601 CENTRAL AVE NE
+
501 CENTRAL AVE NE
RESPONSE TO SKETCH PLAT
COMMENTS

Integrated Design & Architecture
Meeting Date: March 20, 2024

Definition: Usable Open Space

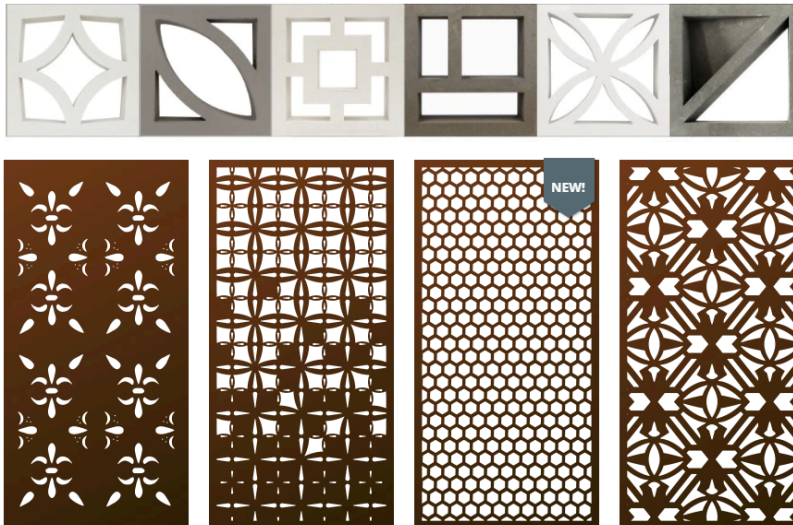
Discussion: Previous discussion (3/6/24) questioned whether or not “usable open space” must be open to the sky? IDA did not interpret the IDO definition to include an open to the sky requirement because the definition mentioned covered patios.

Question/Response: We are assuming our patio will be considered a “Covered Patio” per *Usable Open Space* definition. This patio will be open on two sides with a security screen along the side that is open to Central to keep the site secure, as the patio will be for tenant use only. This screen will provide visual, light, and air to pass through, meaning the patio will still be open on two sides. See below for examples of what this screen could look like.
